SUBJECT: Prince William Sound Regional Citizens' Advisory Council Report:
"A Review of the Proposed New Escort and Support Tugs for
Tanker Operations in Prince William Sound"

A Review of the Proposed New Escort and Support Tugs for Tanker Operations in Prince William Sound

Reference 216-036C

Revision 5

Figure 1 General Arrangement of Damen 4517 Tugboat

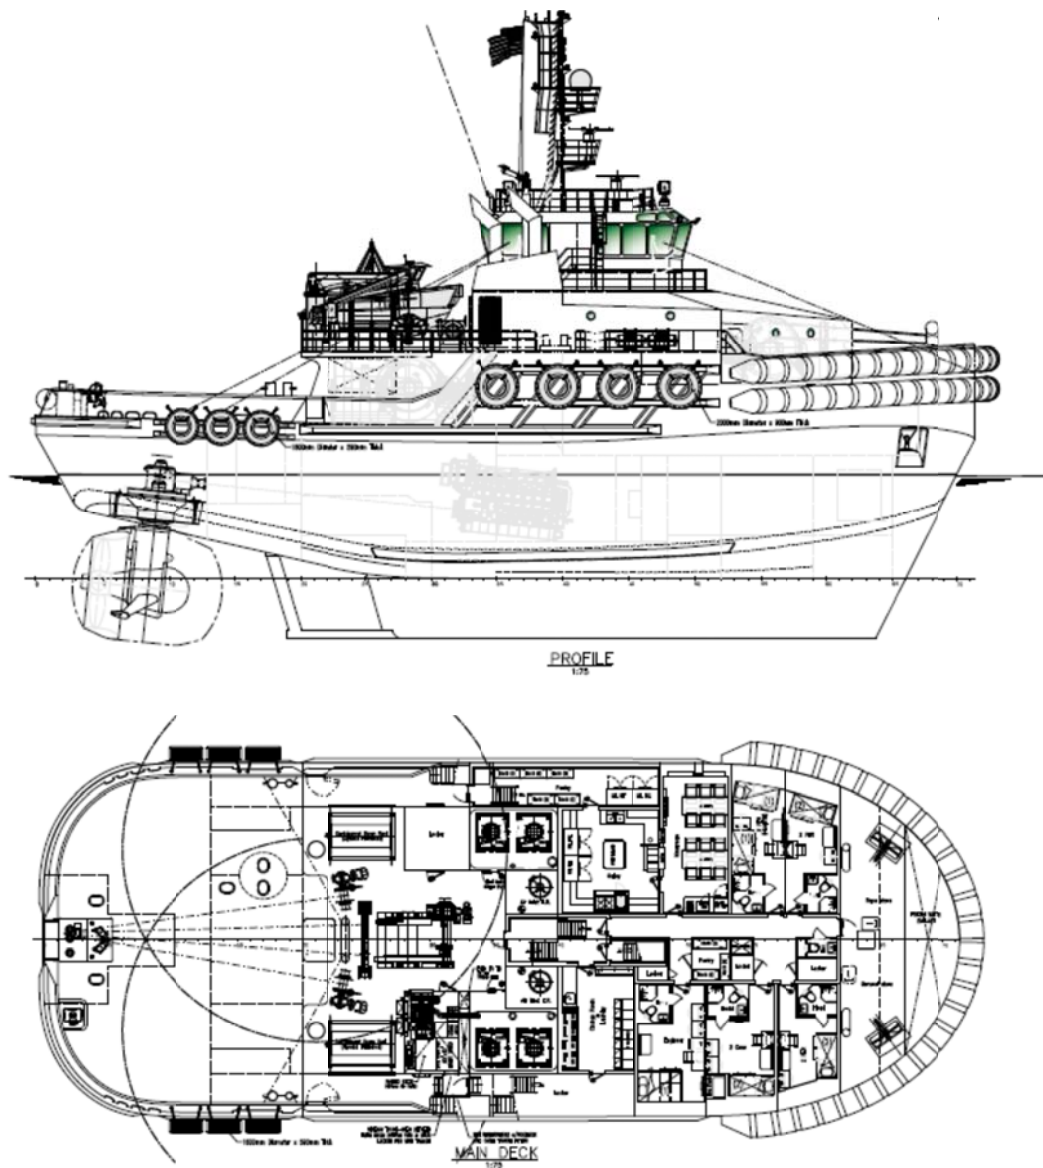
- c. The forecastle deck area presents a significant "pool" to hold water during heavy seas, even with the freeing ports shown there. When this area fills with water the added trapped weight will severely impede the ability of the tug to rise back up in time to avoid the next large wave. ECO/Damen should define how long it will take to clear water from this space in a rough weather transit, and relate that to typical wave heights and wave periods in the area?

- d. In the absence of a Specification for this vessel it is unclear what measures have been taken in the design to cope with the heavy snow and sub-freezing temperatures prevalent in the operating area. ECO must present detailed information with respect to the following measures, and revise the design accordingly to ensure safe operations in Alaska:

7. Clarify whether any topsides deck drains are routed inside deckhouses. Note: although this is common practise in many shipyards it is an absolute "No-No" in the design of ships for arctic/subarctic conditions. Downpipes MUST be external to deckhouses in their entirety and should be designed to be easily removable/replaceable in the event of plugging/freezing.

8. All window wipers must be equipped with heating elements and with provision for adding anti-freeze to window washing solution?
-
- e. There is no bow thruster on this tug. It is our experience that when a tug of this size is used for ship-handling, as these will be, Owners find that a bow thruster is highly desirable and even essential. Even though the Z-drives give significant control of heading, a bow thruster can provide a significant controlling influence over lateral movement at low speeds and reduce the amount of stern thrust needed to control the tug. Given the high windage of this tug, and the presence of a very large skeg, hindering lateral mobility, a bow thruster should be strongly considered.

- 1. increase the fendering by adding 2,000 mm x 900 mm tires forward of frame 52 (on top of the cylindrical fenders), and
 - 2. replace the 1,600 mm x 590 mm tires aft with 2,000 mm x 900 mm tires

- l. Ice Strengthening: No information was provided with respect to the structural design of these tugs, and in particular with regard to the ice-strengthening of the hulls. Periodic ice impact damage is a fact of life with the present tugs in the area and measures must be taken to mitigate that risk. ECO must provide details of any ice-strengthening measures taken with regard to the hull, appendages (such as bilge keels) and the Z-drives and propellers.).

Figure 3 General Arrangement of *Damen 3212* Tugboat

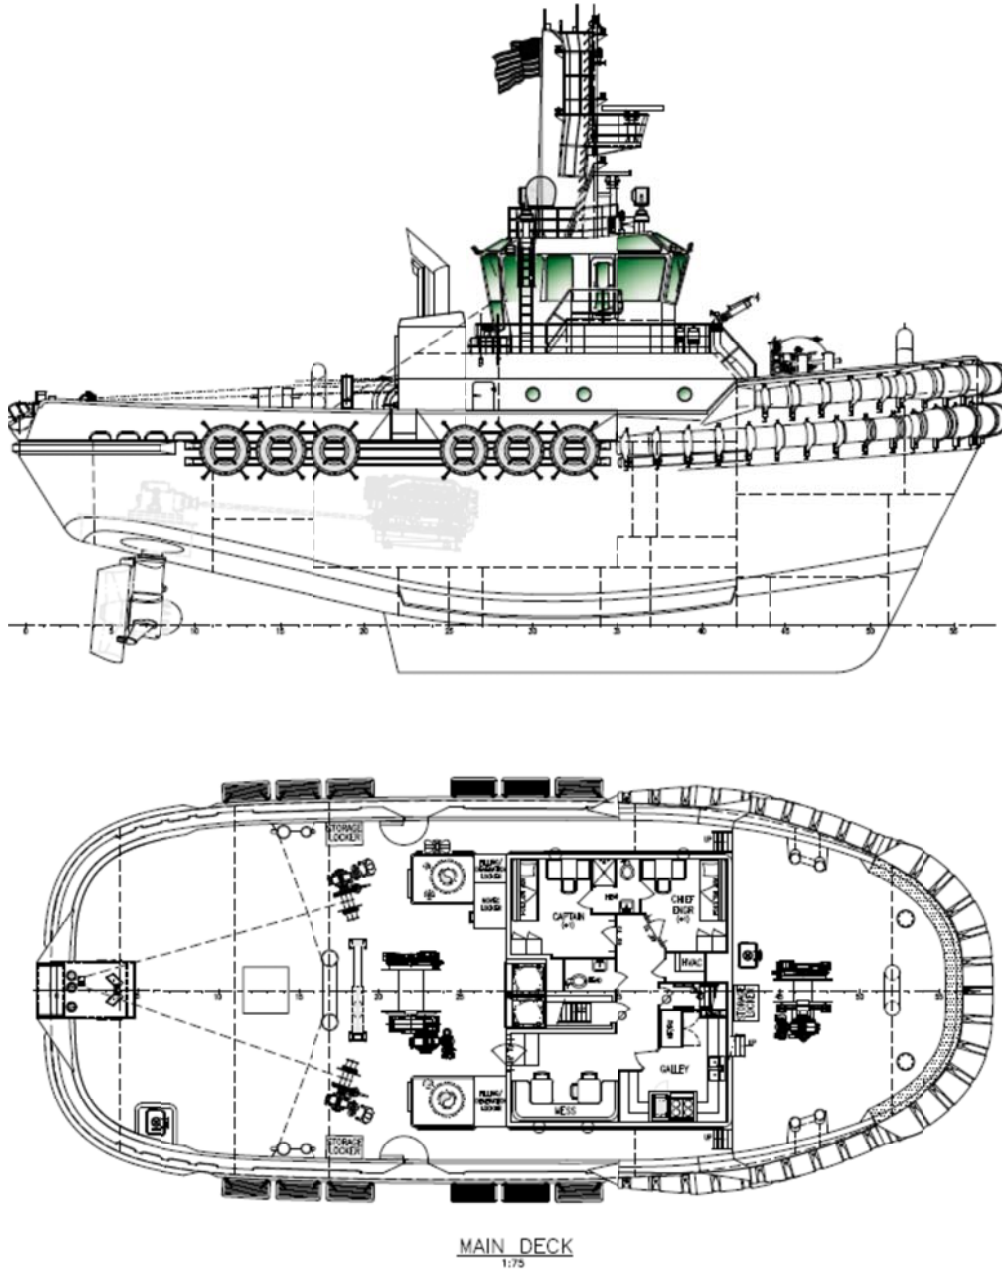
- a. The tugs are fitted with fixed pitch (not controllable pitch) propellers. This will be problematic for indirect escort work, as the probability for stalling the engines is very high. An analysis of available engine torque vs propeller load should be presented to show that there is no risk of engine stall throughout the full operating range of rpm and azimuth angles
- b. Details must be provided demonstrating the expected indirect and direct towing performance at 8 and 10 knots, in compliance with a recognized standard for escort towing stability

- c. Details must be provided for the escort winch and all associated cordage; the winch must have a render-recover capability in keeping with the escort rating of the tug. The data sheet indicates a "dynamic line force" of only 15 tonnes for this winch which is seriously inadequate for escort work in Alaskan waters. It is strongly recommended that this winch be electric driven rather than hydraulic for the required performance, as well as being far superior in cold climate operations. It is further noted that this is a single drum winch only which provides no quick backup in case of a line break. That seems an inappropriate selection for such a critical mission. Winch specification must be reviewed/revised in the context of predicted indirect forces

- g. Ladder from fore deck to boat deck is very steep ... potentially dangerous, especially in snow or icy conditions. It is also strongly advised that any exterior ladders and gratings be constructed of GRP to minimize potential for snow and ice accumulation. ECO to define what is presently specified for ladders and gratings and if necessary change for best crew safety

- j. Deck locker space is totally inadequate for towing gear etc. in the cold climate. Provide details to demonstrate suitable drainage, ventilation and heating in ALL gear lockers to ensure lines are all readily usable in all weather conditions
